Integrated
Environmental
Solutions

Subject: L.E. CARPENTER & COMPANY, WHARTON, NEW JERSEY, NJD002168748
Response to NJDEP & USEPA Comments dated July 26, 2002

Illustration A
Particle Diameter and Surface Area Relationship Chart

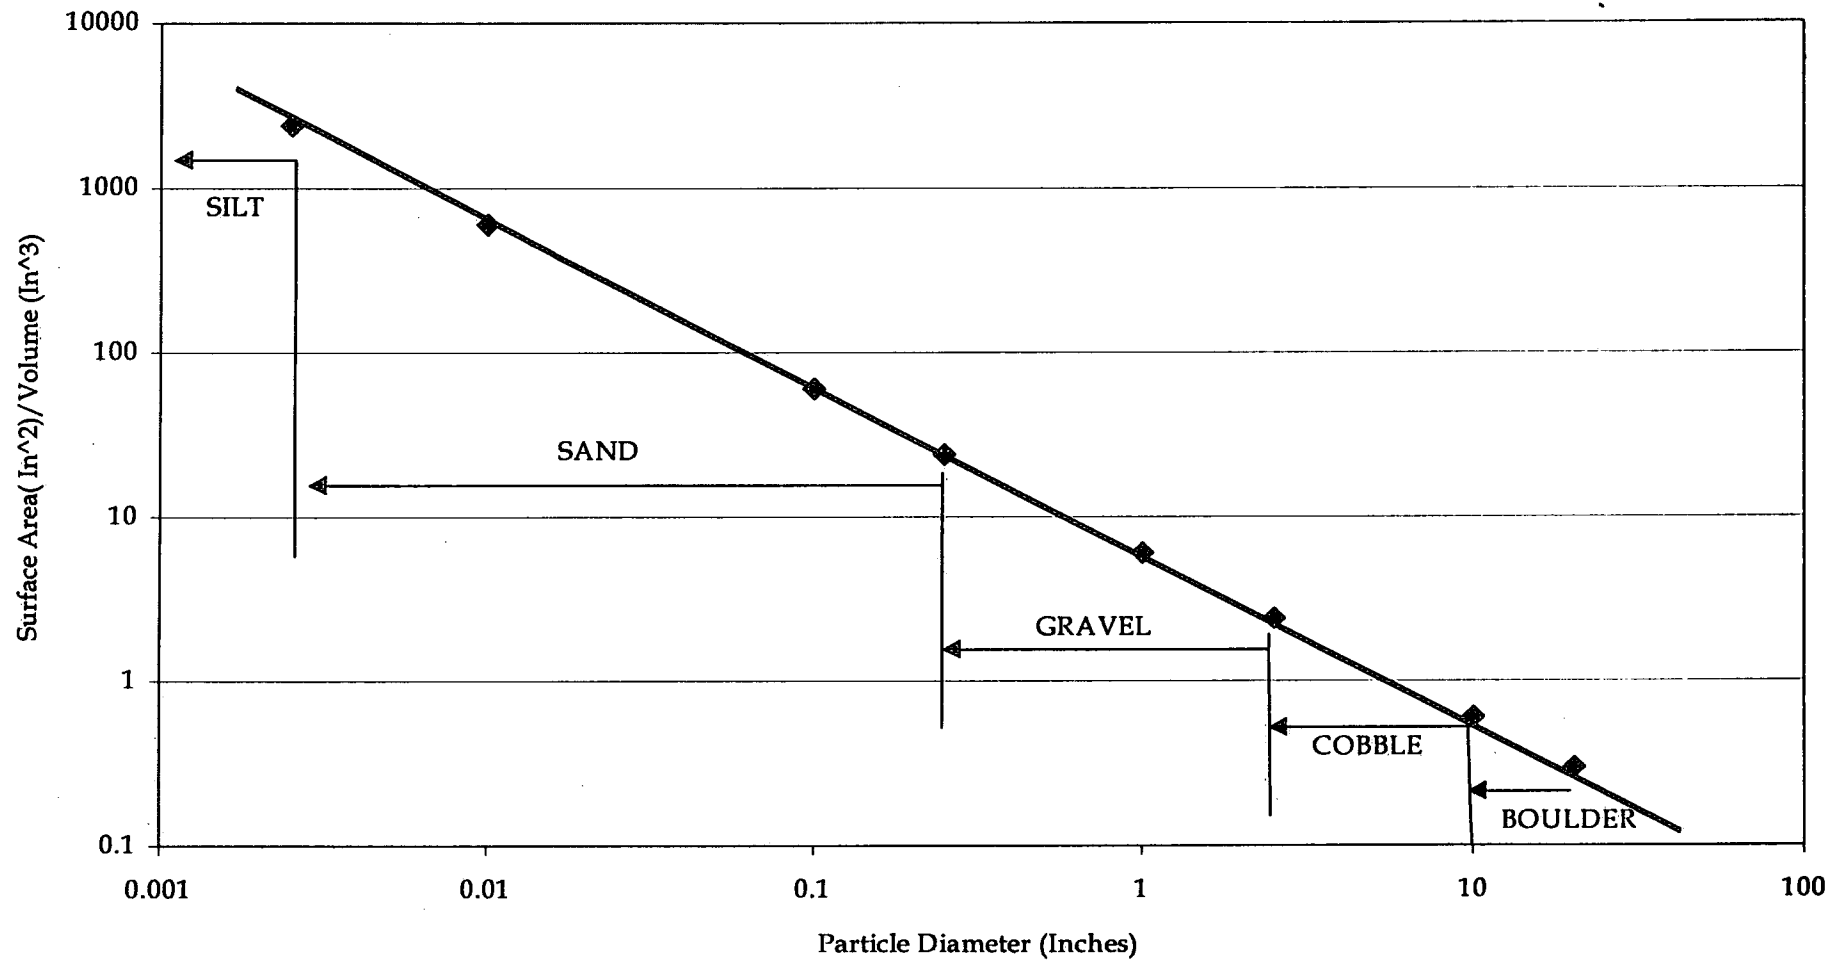
4. Response to NJDEP Comment No. 3 regarding washing of the larger-sized fraction:

As noted in Section 3.3, the amount of residual product left on the surfaces of the larger particles is very low. Illustration A (attached) shows the relationship between particle diameter and surface area. The following computations illustrates just how small the residual product mass on the surface of the coarse fraction would be:

First, we assume 50 percent of the soil is greater than 2.5 inches in diameter, the particles are generally spherical and product coatings are of uniform thickness. Then, by dividing the entire soil distribution for the Type 1 soils (See Appendix E of the Free-Product Report) into quartiles by percent mass and extrapolating the median particle diameter for each quartile, we can arrive at the relative total surface areas that can be equated to percent product on soil surfaces (Illustration B). The resulting computations show that 99.83 percent of the product on particle surfaces will be removed with the < 2.5-inch soil fraction. The benefits of washing the larger fraction would be miniscule and not cost effective. ✓
